LETTER AND U S NAVY RESPONSE TO COMMENTS TO DRAFT TREATABILITY STUDY  
WORK PLAN OPERABLE UNIT 2 (OU2) NAS CECIL FIELD FL  
12/10/1993  
ABB ENVIRONMENTAL

**Subject: RI/FS Program, NAS Cecil Field, Operable Unit (OU) 2  
Treatability Study Workplan Response to Comments**

Draft Treatability Study Workplan for Operable Unit 2  
Naval Air Station Cecil Field, Jacksonville, Florida

FIGURE 13-1  
SCHEDULE FOR BENCH SCALE  
TREATABILITY EVALUATION

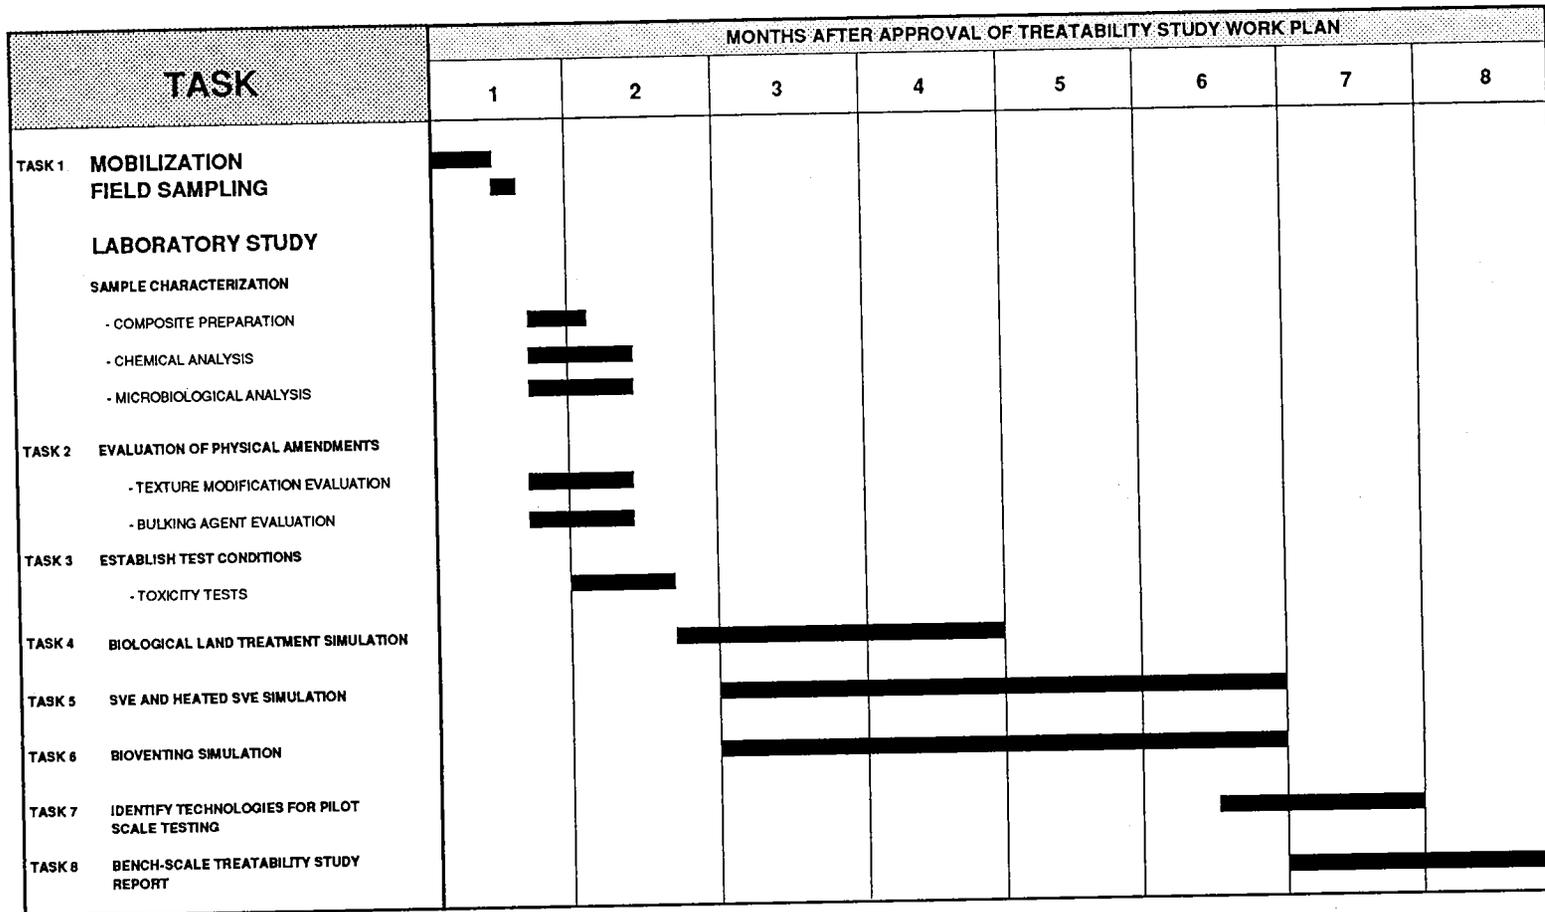
3.	Section 13.0, which deals with the project schedule, was extremely general. A more detailed schedule, such as shown on page 36 of the <u>Guide for Conducting Treatability Studies Under CERCLA</u> should be included in the Draft Work Plan.	A more detailed schedule has been prepared (Attachment A) which addresses the elements specified in the <u>Guide for Conducting Treatability Studies Under CERCLA</u> .
Specific Comments

FIGURE 13-1  
SCHEDULE FOR BENCH SCALE  
TREATABILITY EVALUATION

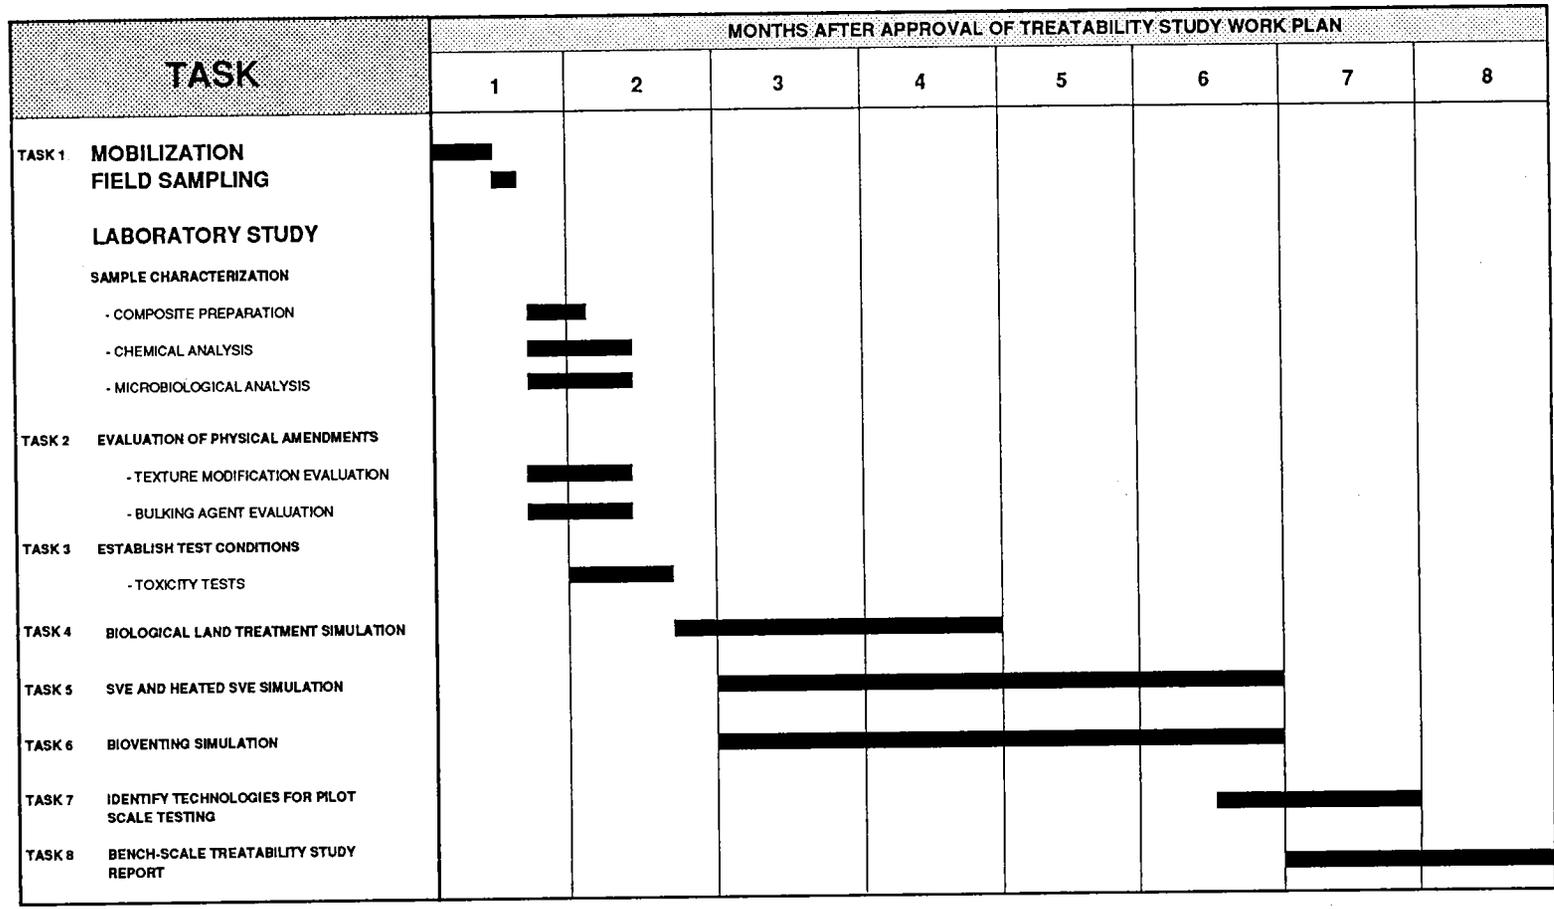
3.	Section 13.0, which deals with the project schedule, was extremely general. A more detailed schedule, such as shown on page 36 of the <u>Guide for Conducting Treatability Studies Under CERCLA</u> should be included in the Draft Work Plan.	A more detailed schedule has been prepared (Attachment A) which addresses the elements specified in the <u>Guide for Conducting Treatability Studies Under CERCLA</u> .
Specific Comments
